STAFF REPORT: 09/11/2024 REGULAR MEETING

APPLICATION NUMBER: HDC2024-00425

ADDRESS: 1474 W. BOSTON

SCOPE: REPLACE WOOD WINDOWS WITH ALUMINUM-CLAD WOOD WINDOWS

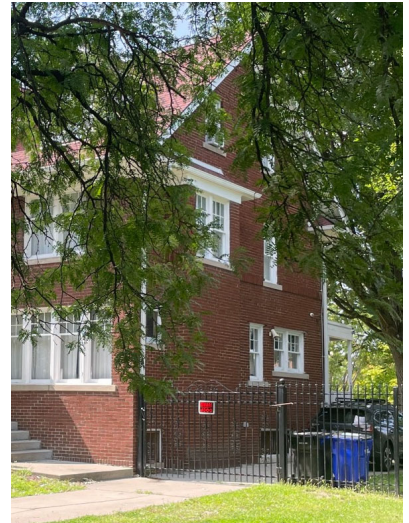
- The front upper story and the east side windows are particularly visible from the public and are proposed for replacement with aluminum clad-wood windows. Except for the front dormer windows, which are 2/4 wood casements, the other front windows are 6/1 cottage windows. The side wall has 6/1 double-hung wood windows. All windows have true divided-light mullions. It is staff’s opinion that all of these true divided-light windows are distinctive, character-defining features. Their loss would substantially detract from and destroy the historic appearance of the building. (See photos 1-4)

- Photo documentation establishes that the condition of the original wood windows is repairable and not beyond repair.
- No repair estimate was provided.
- It is staff's opinion that the removal of the original wood windows with true divided light and in 3 windows a change from casements to double-hung windows greatly alters the original *scale, design, and materiality* of the building's fenestration and the new windows are incompatible and inappropriate for this historic property. Therefore, this work item does not meet the Secretary of the Interior's Standards for Rehabilitation and does not conform to the district's Elements of Design.
